**ADA ASSESMENT REPORT  
COMCARE TRANSITIONAL HOUSING  
731 HUNTER, WICHITA, KS  
Report Date: July 22, 2008**

The following ADA site assessment was performed on June 25, 2008 upon request of Paula Downs, Facilities Project Services Manager for Sedgwick County Project Services.

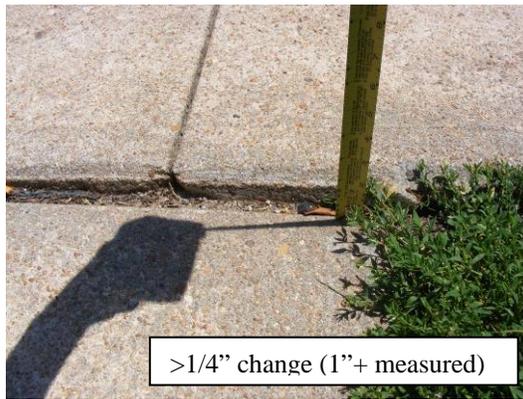
**EXISTING CONDITION: No accessible route exists connecting the parking lot with the route (sidewalk) to the office and apartments due to an abrupt change in level (curb) of approximately 3”.** According to ADAAG, changes in level up to 1/4 in (6 mm) may be vertical and without edge treatment (see Fig. 7(c)). Changes in level between 1/4 in and 1/2 in (6 mm and 13 mm) shall be beveled with a slope no greater than 1:2 (see Fig. 7(d)).

(ADAAG 4.3, 4.5.2, 4.7, 4.29)

Ensure that at least one accessible path of travel connects the parking area to the accessible route. Provide an ADAAG compliant curb ramp (with detectable warnings) if necessary or otherwise ensure that abrupt changes in level do not occur.
